Response To Comments
on the
Draft Environmental Impact Analysis

Prepared for the
Zero Emission Forklift Regulation

**California Air Resources Board
1001 I Street
Sacramento, California, 95814**

**Released June 26, 2024
to be considered at the
June 27, 2024 Board Hearing**

Figure 1. Historical national forklift sales reported by ITA from 1995 through 2020

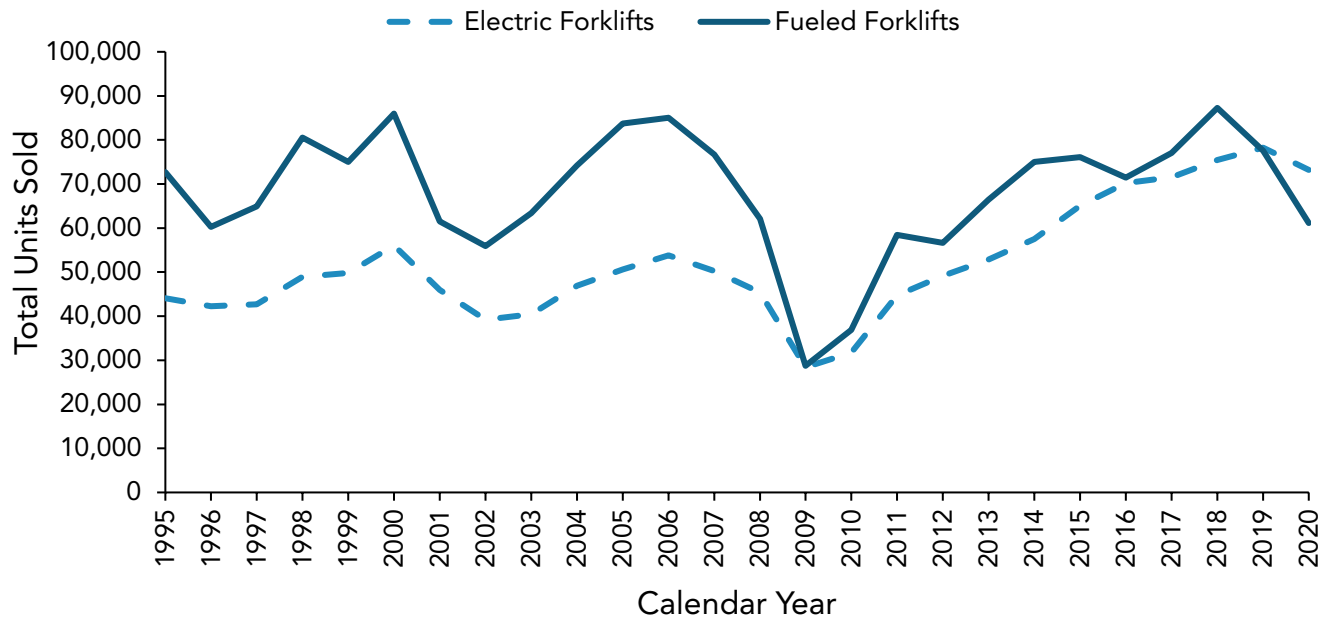
Comment-1: The commenter states, “Actual impacted forklifts far exceed CARB estimate: CARB has modelled the total affected forklifts of approximately 95,000, though this inventory count is less than a third of the values produced from the 2017 CARB/SSRC Study. CARB assumes that the internal combustion engine (ICE) forklift population remains stagnant though time has shown an increase in forklifts in the state due to an increase in goods movement. After evaluating forklift fleet owners and operators, CARB’s proposal will actually impact over 390,000 ICE forklifts – over three out of every four forklifts in the state.”

Regarding growth, CARB staff used the historical national sales as reported by ITA from 1995 through 2020, shown in Figure 1 below. These historical national sales of new LSI forklifts show stagnant LSI forklift sales over the last 25 years, with sales in the 2010s similar to sales in the 1990s and 2000s, and a decrease in new LSI forklift sales between 2018 and 2020. The

data show that electric forklift sales are increasing over time. Taken together, the data show that overall demand for forklifts is growing but the increase in demand is being met by an increase in sales of electric forklifts, not LSI forklifts. Based on this analysis, CARB’s emission inventory does not reflect an overall growth in the LSI population in the future.

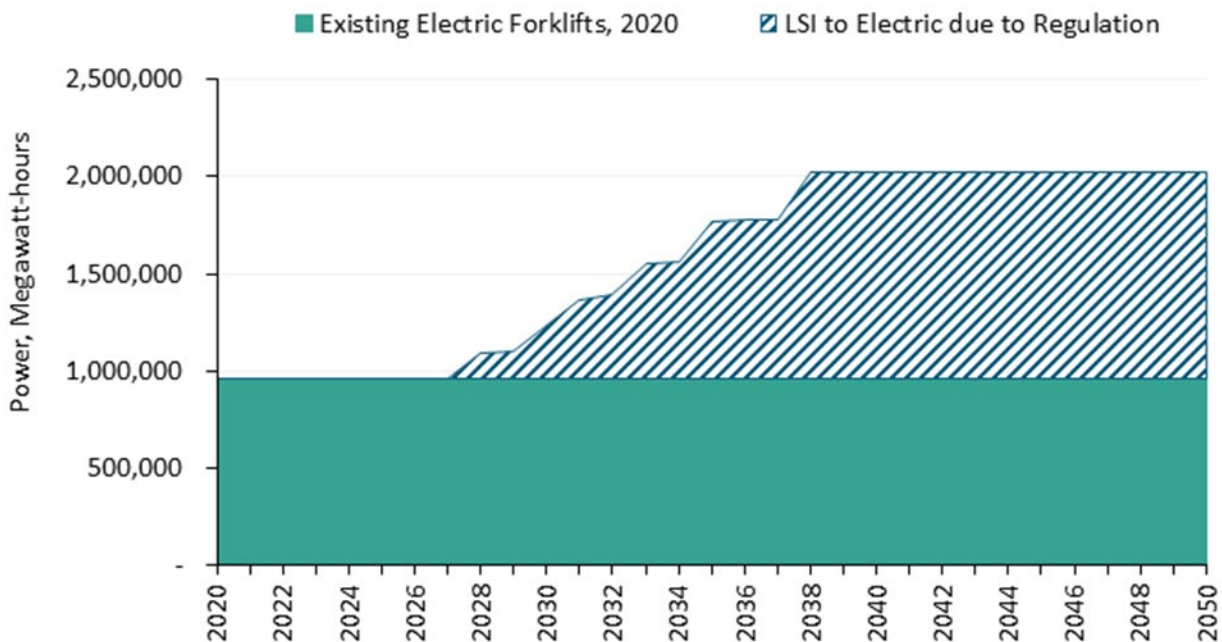
15-6-1: The commenter states “The magnitude of the conversion to ZEF was significantly misrepresented in the November 2023 Initial Statement of Reasons, leading to further corrections under this 15-day Modification.

This "typographical error" represents a mistake that under-represented the magnitude of this Regulation's impact on electrical loads and the availability of electricity in California. Each unit of measurement (i.e., "megawatt," "gigawatt," and "terawatt") is about 1,000 times the size of the next smaller one. For example, one gigawatt is 1,000 times larger than a megawatt, and one terawatt is 1,000 times larger than a gigawatt. In our December 2023 comment letter, CMTA expressed our significant concern about the readiness of the energy grid to support this Regulation and other vehicle electrification policies."

Response: No changes were made in response to this comment. CARB staff acknowledges and regrets the typographical error. However, CARB staff disagrees that the typographical error "represents a mistake that under-represented the magnitude of this Regulation's impact on electrical loads and the availability of electricity in California."

The 15-Day changes made are purely typographic and did not impact staff's analysis or methodology related to or depiction of the Regulation's impact on electrical loads and the availability of electricity in California. As seen in the excerpt quoted by the commenter, despite the typographic error in the units, the expected increase is still the same roughly 0.4 percent of the statewide gridded energy demand, which was clearly and correctly stated. Additionally, although in Appendix D, there was a typo in one sentence of the text ("MWh" had to be corrected to "GWh"). Immediately adjacent to the typo was a graph showing the correct units, Figure 17 of Appendix D: 2023 Large Spark Ignition Forklift Emission Inventory.

The solid area at the bottom represents the annual electricity demand from existing electric forklifts, and the top, striped area represents the additional annual electricity demand from electric forklifts that will be required by the Proposed Regulation over the course of

Therefore, despite the typo, the figure mentioned above in Appendix D showed the correct energy demand numbers, and disclosed the correct 0.4 percent increase of the statewide gridded energy demand.
